# HISTORIC AND DESIGN REVIEW COMMISSION

July 18, 2018

**HDRC CASE NO:** 2018-354  
**ADDRESS:** 402 CEDAR ST  
**LEGAL DESCRIPTION:** NCB 2966 BLK 1 LOT 6  
**ZONING:** RM-4, H  
**CITY COUNCIL DIST.:** 1  
**DISTRICT:** King William Historic District  
**APPLICANT:** Mark Hogensen  
**OWNER:** Mark Hogensen  
**TYPE OF WORK:** Exterior modifications, reconstruction of existing additions, replace porch decking, roof replacement  
**APPLICATION RECEIVED:** July 5, 2018  
**60-DAY REVIEW:** September 3, 2018  
**REQUEST:**

PROPOSED ELEVATIONS

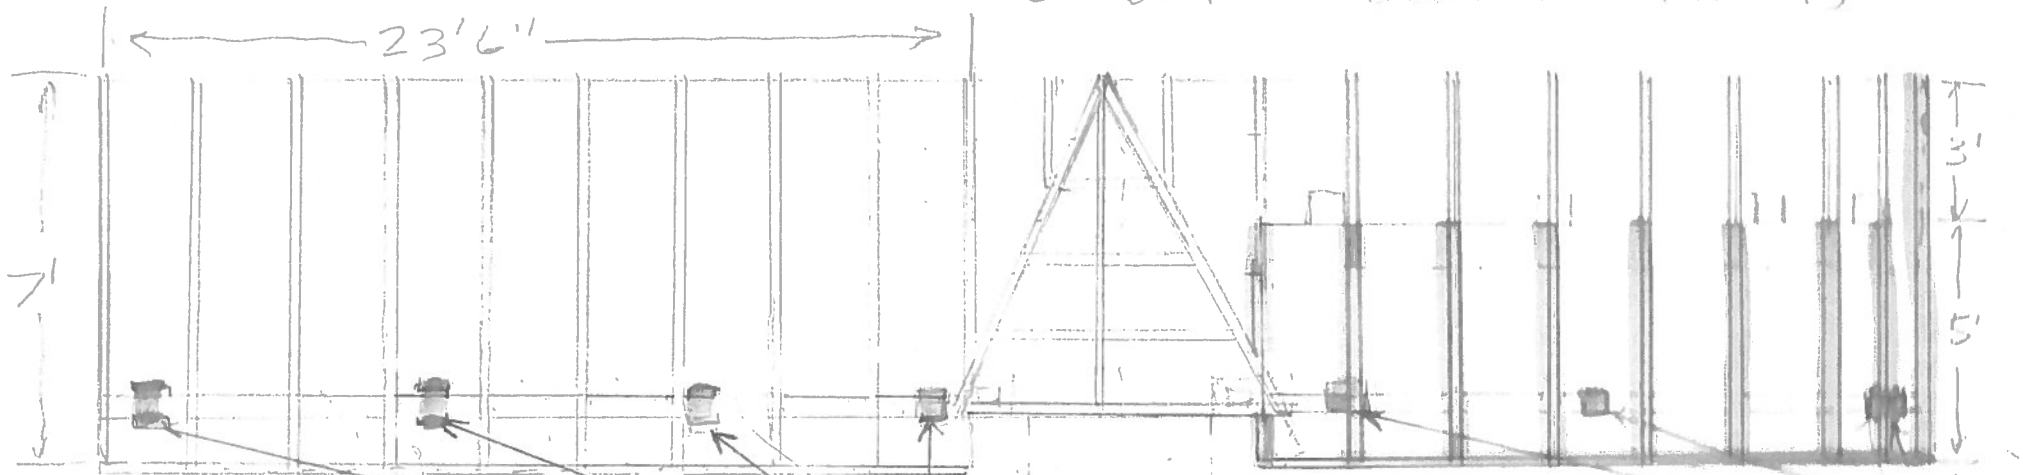
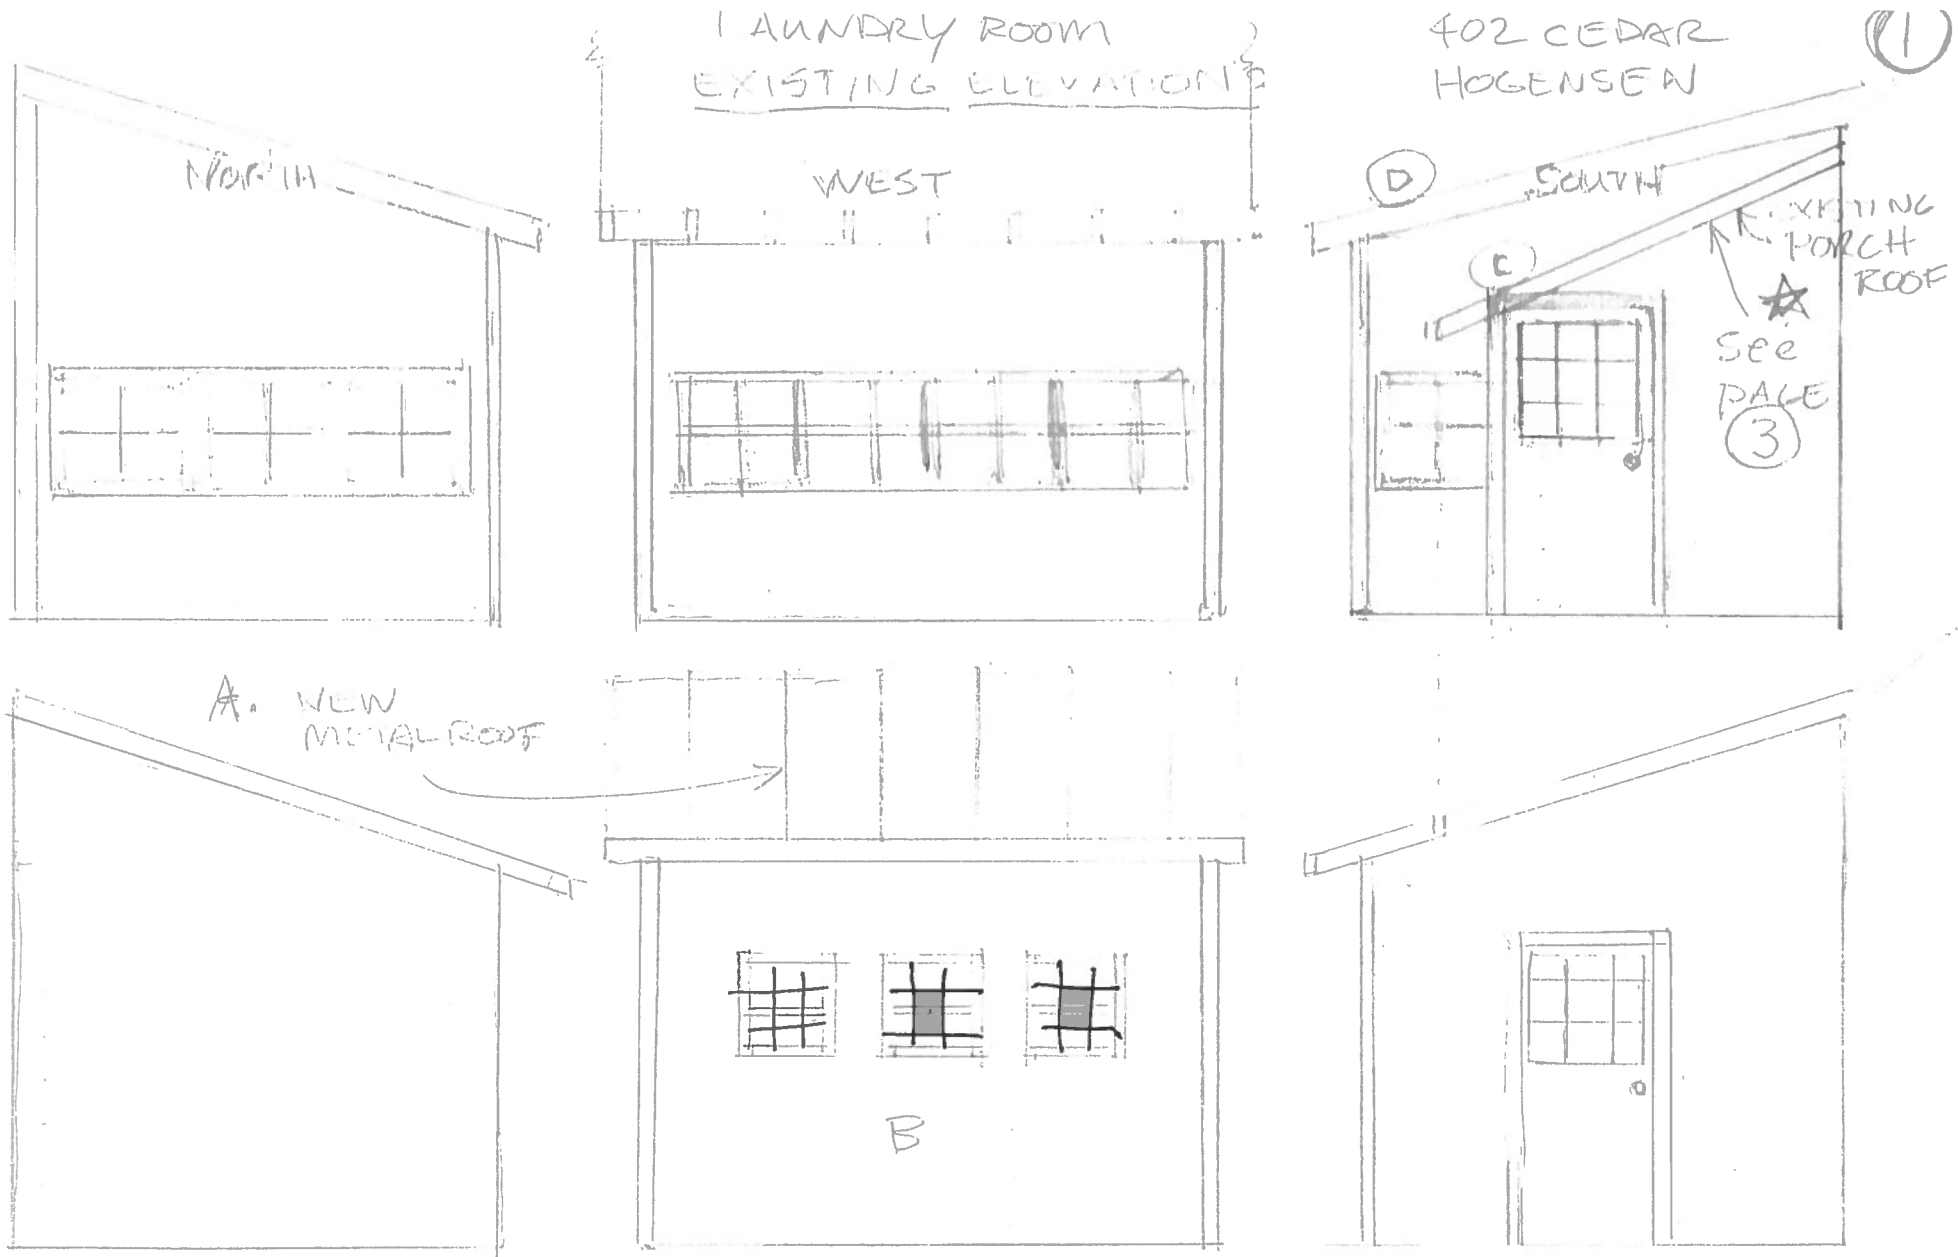
- c. **FRONT PORCH ADDITION** – The applicant has proposed to construct a new front porch roof on the right side of the front elevation to match that which currently exists on the left side. Within the construction of the proposed addition, the applicant has proposed to modify the pitch of the existing porch roof and add square wood columns to be 6x6. Generally, staff finds the proposed porch roof modifications and addition to be appropriate. The proposed columns should be painted and feature both base and capital trim.

- d. **PORCH DECKING** – The existing porch is concrete. The applicant has proposed to install a composite decking system to feature five inches in width per deck board. The 1951 Sanborn Map notes a concrete porch. The Guidelines for Exterior Maintenance and Alterations 7.A.iii. notes that original porch materials should not be covered by carpet, tile or other materials unless they were used historically. Staff finds the proposed composite decking installation to be inconsistent with the Guidelines.

- e. **ROOFING** – The applicant has proposed to remove the existing, asphalt shingle roof and install a standing seam metal roof. Per the Guidelines for Exterior Maintenance and Alterations 3.B.vi. metal roofs should be used on structures that historically featured one, or where a metal roof is appropriate for the architecture. The 1951 Sanborn Map does not note a roof material. Generally, staff finds that the installation of a standing seam metal roof is appropriate. The proposed roof should feature panels that are 18 to 21 inches wide, seams that are 1 to 2 inches high, a crimped ridge seam and a standard galvalume finish. An inspection is to be scheduled with OHP staff prior to the installation of roofing materials to insure an inappropriate ridge cap is not installed.

- ii. That the size of the additions does not increase and that materials match those found on the existing structure.
- 2. Staff recommends approval of item #2, the construction of a new porch roof and porch modifications based on finding c with the following stipulations:

- i. That the proposed cedar columns be painted and feature capital and base trim. Column details are to be submitted to staff for review and approval.

- 3. Staff does not recommend approval of item #3, the installation of porch decking based on finding d.
- 4. Staff recommends approval of item #4, the installation of a standing seam metal roof based on finding e with the following stipulation:

- i. The proposed roof should feature panels that are 18 to 21 inches wide, seams that are 1 to 2 inches high, a crimped ridge seam and a standard galvalume finish. An inspection is to be scheduled with OHP staff prior to the installation of roofing materials to insure an inappropriate ridge cap is not installed.
